UNITED STATES
NUCLEAR REGULATORY COMMISSION
WASHINGTON, D. C. 20555

APPLICANT: Public Service Electric & Gas Company (PSE&G)
FACILITY: Hope Creek Generating Station
SUBJECT: SUMMARY OF STRUCTURAL AND GEOTECHNICAL ENGINEERING
BRANCH (SGEB) MEETING

On August 1, 1984, a meeting was held in the Bethesda, Maryland offices of the NRC to discuss the remaining SGEB-Structural audit open items identified in the Draft SER. A list of meeting attendees is included as Enclosure 1 to this meeting summary.

FIGURE A-16-9

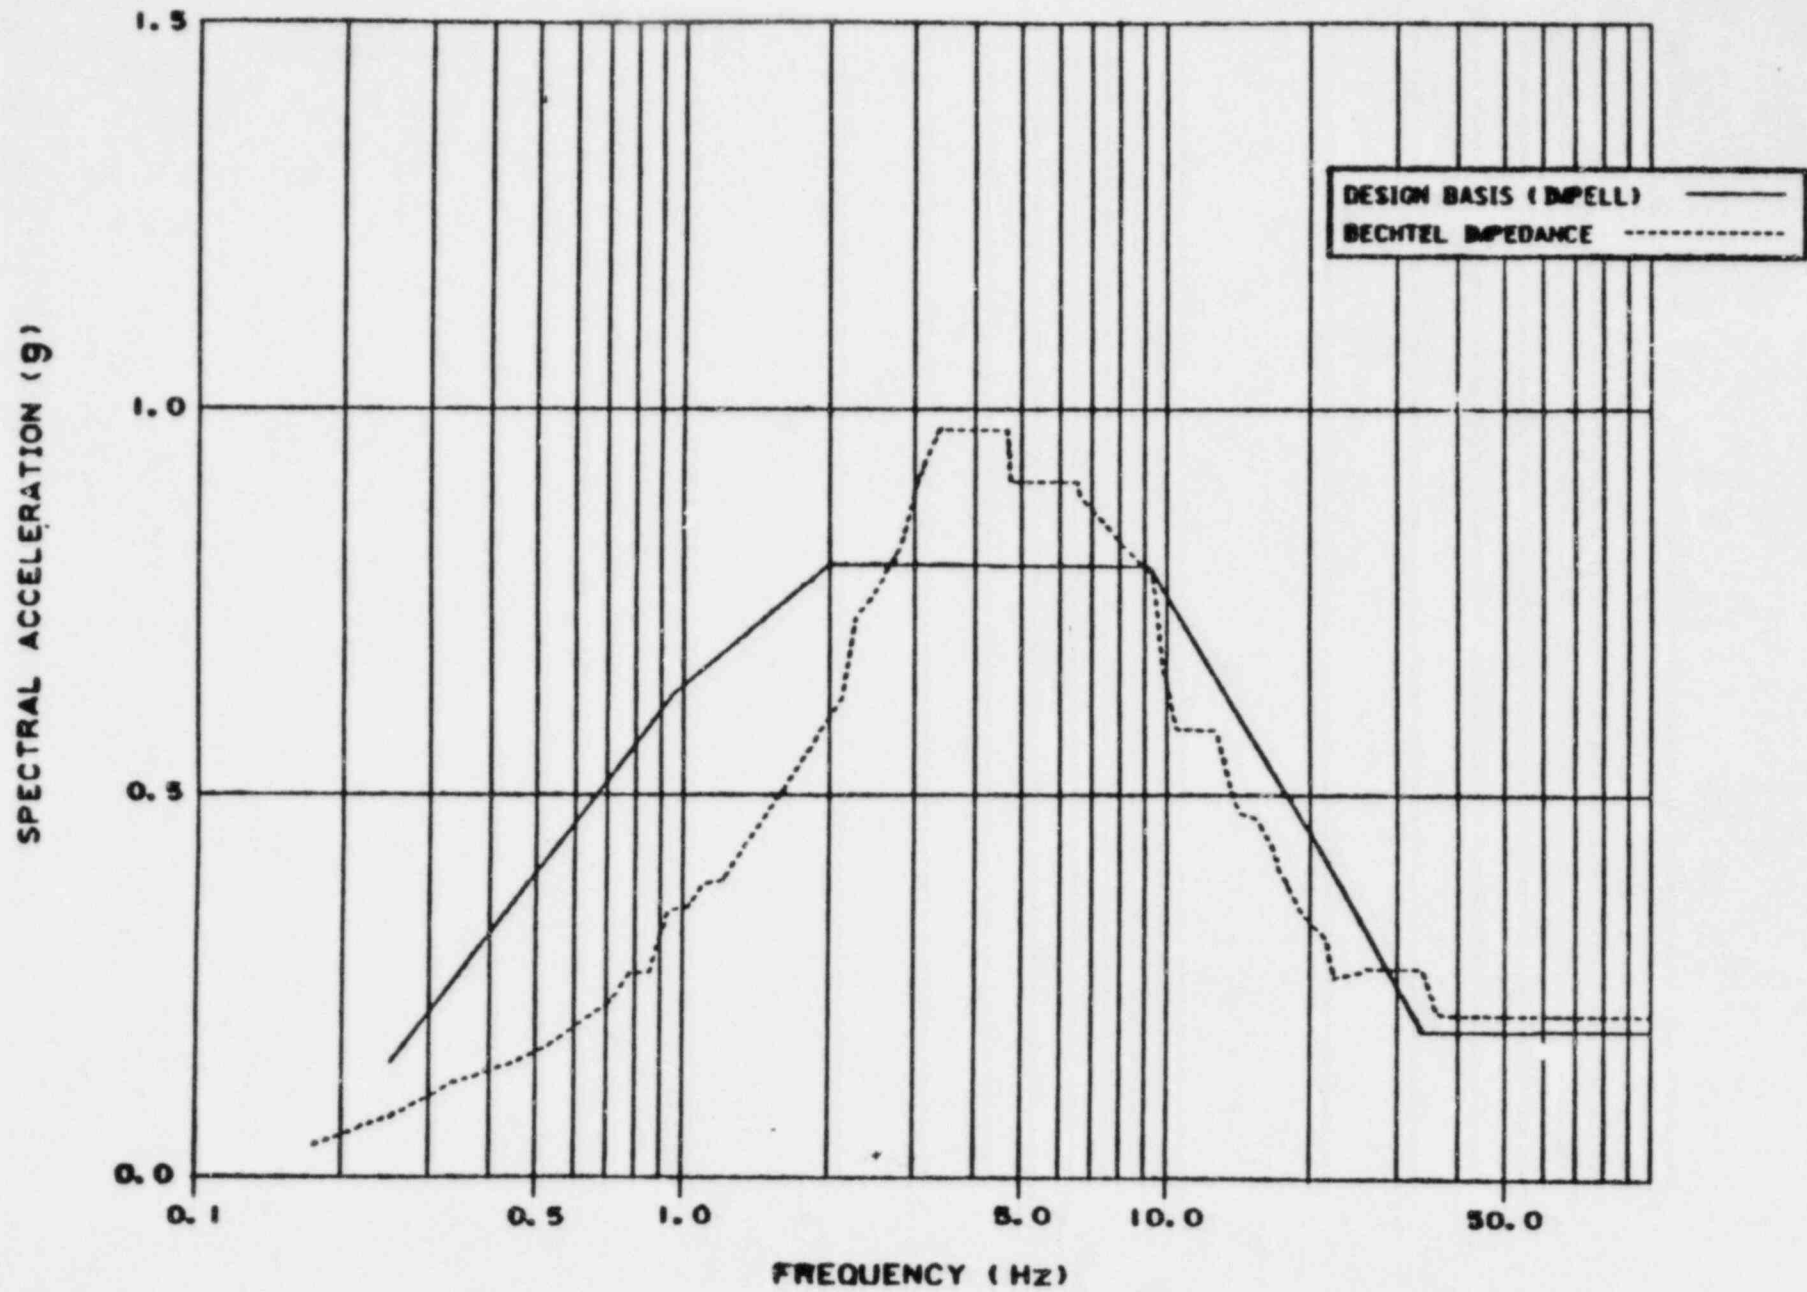
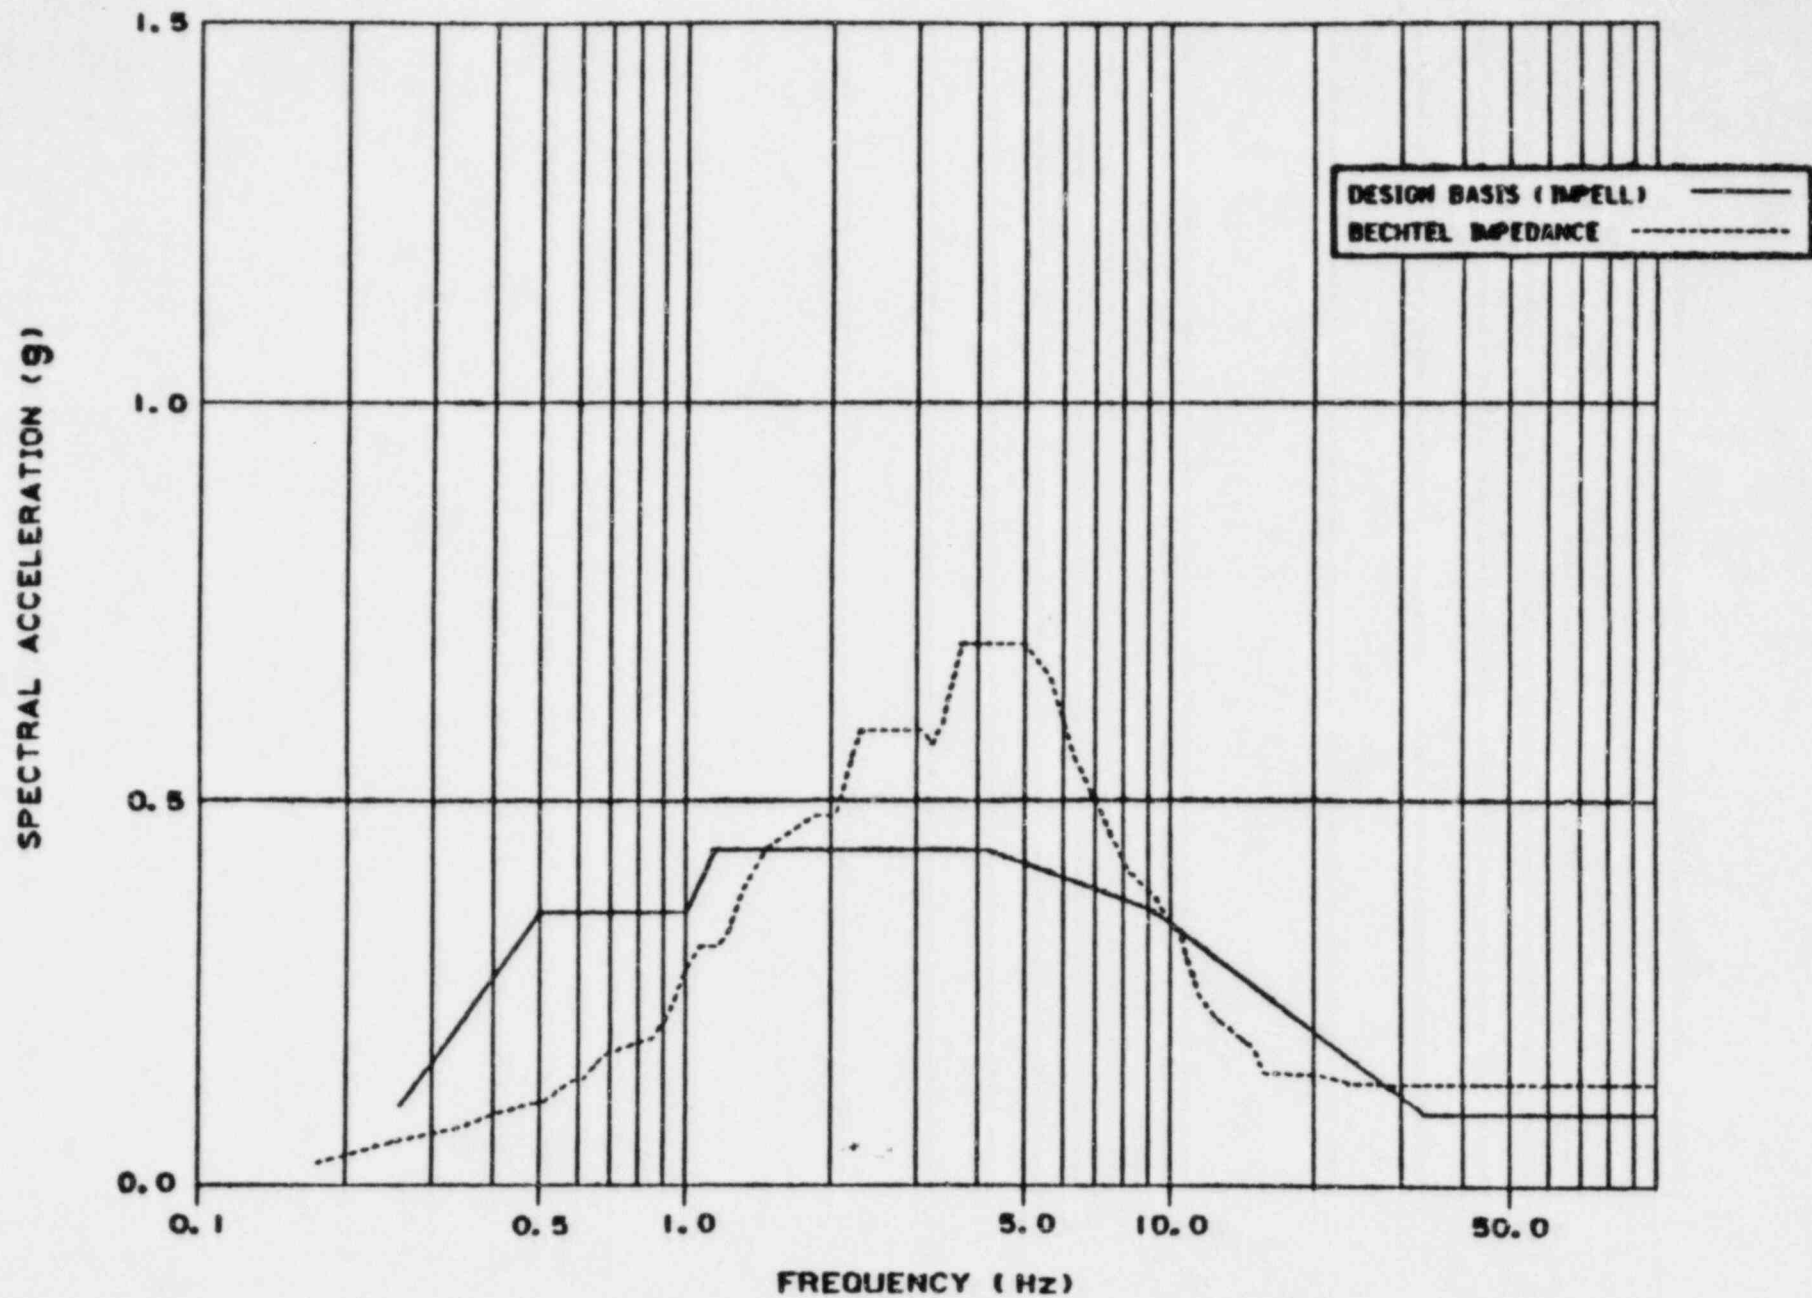
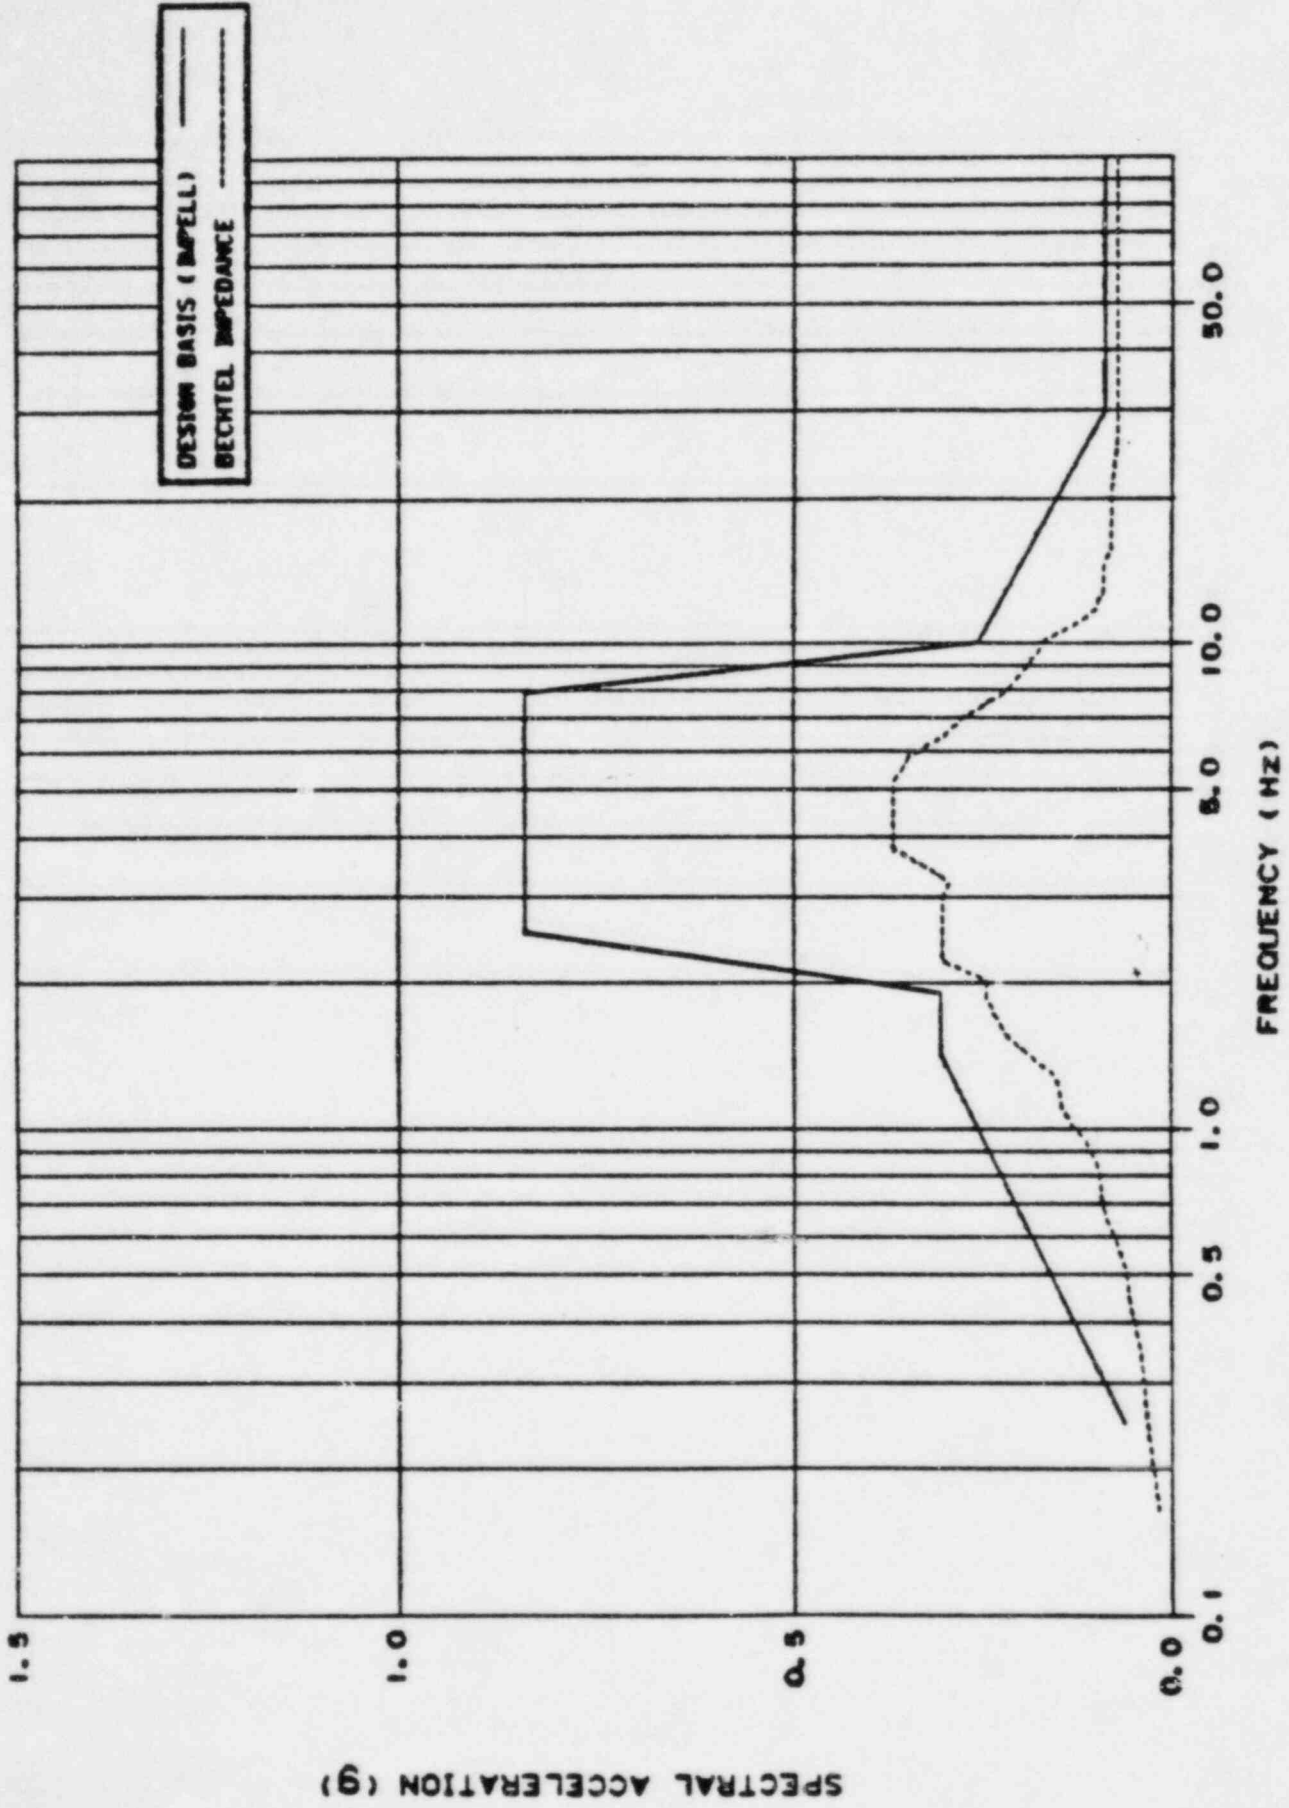
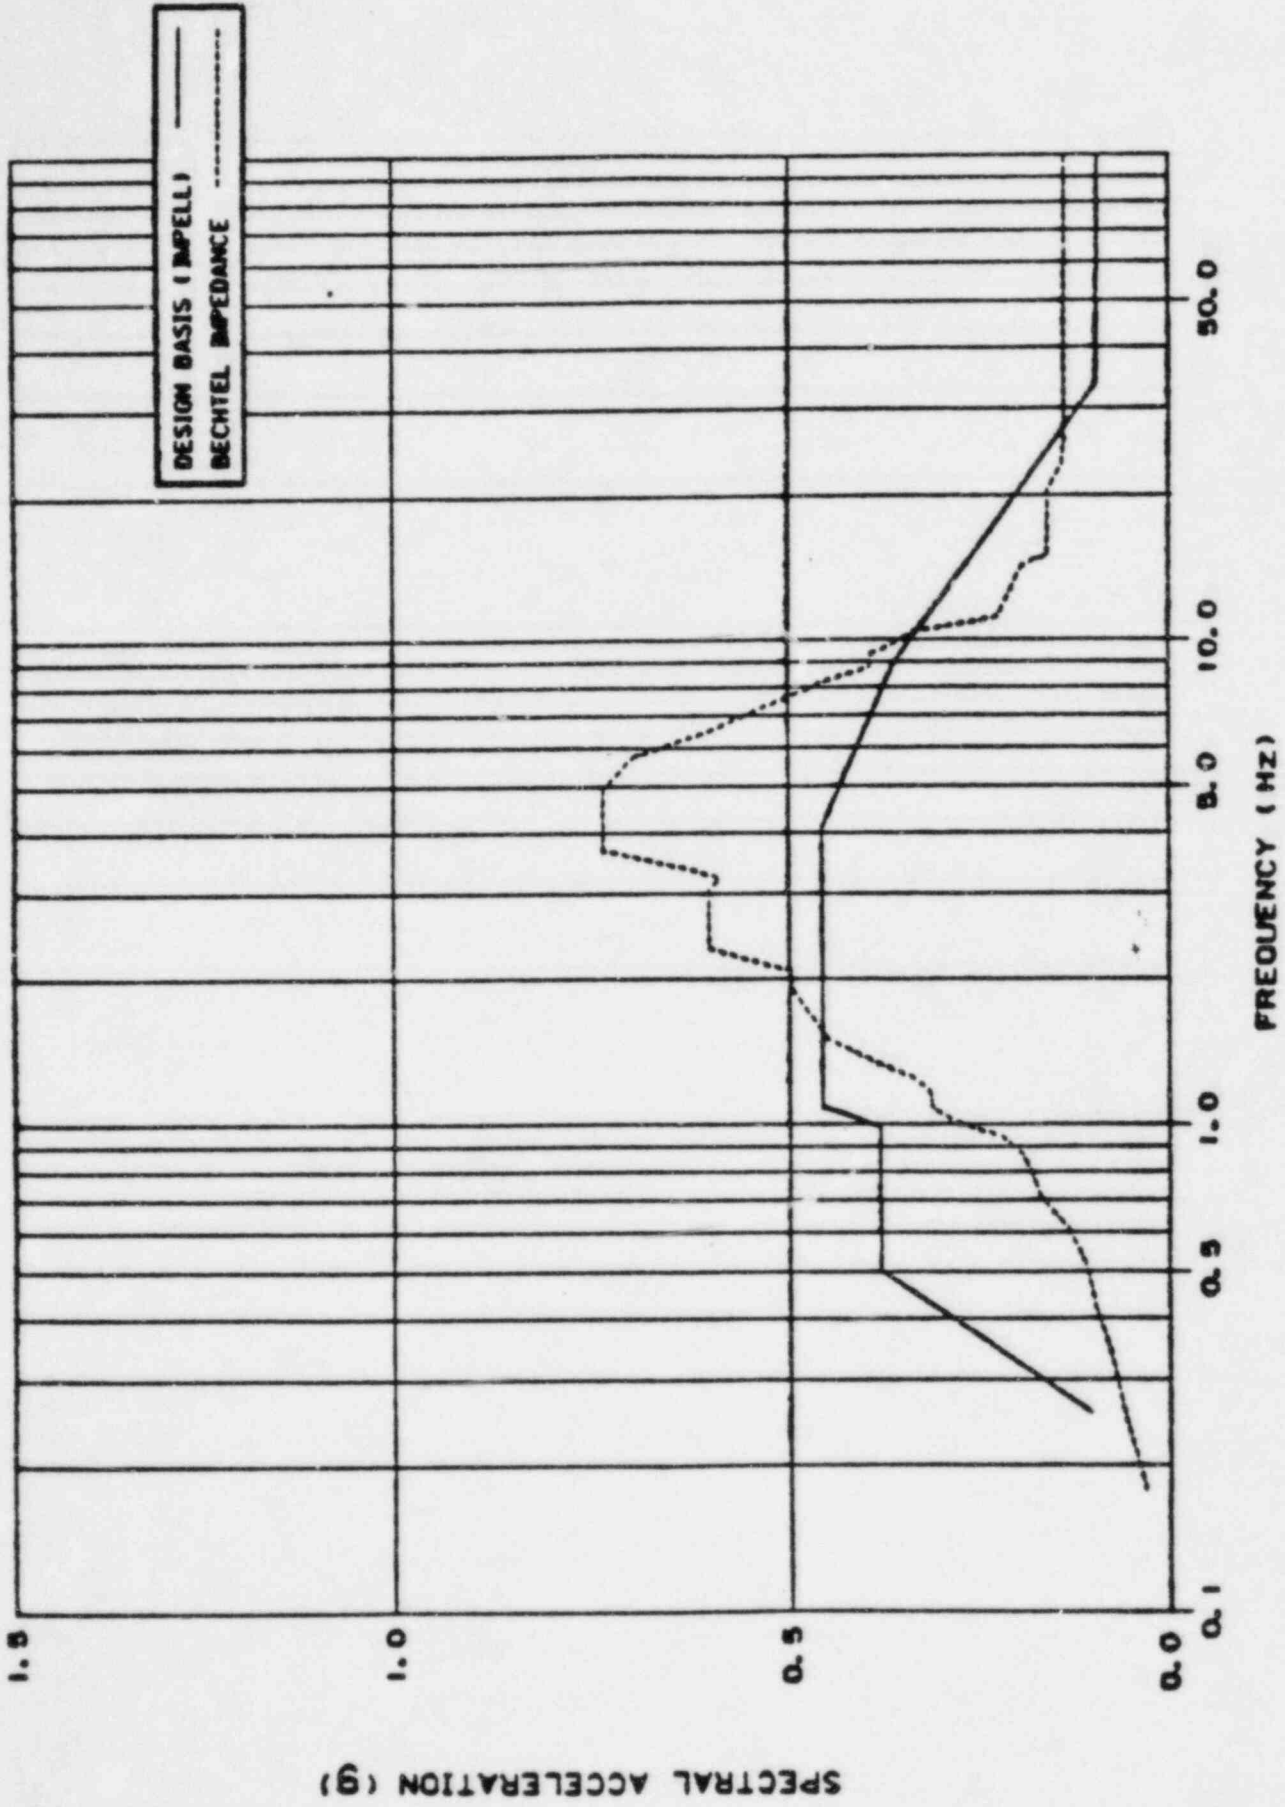
Question No.: A-16

Figures A-16-1 to A-16-18 show the comparison of the 2 percent damping response spectra obtained from the design basis finite element and the impedance approach seismic soil-structure interaction analyses. The impedance approach response spectra generally are enveloped by those obtained from the design basis analyses at elevation 114.0 feet of the SWIS. For other elevations, the impedance approach spectral accelerations exceed the design basis spectral accelerations in some frequency ranges. These ranges vary approximately between 1.5 and 10.0 Hz.
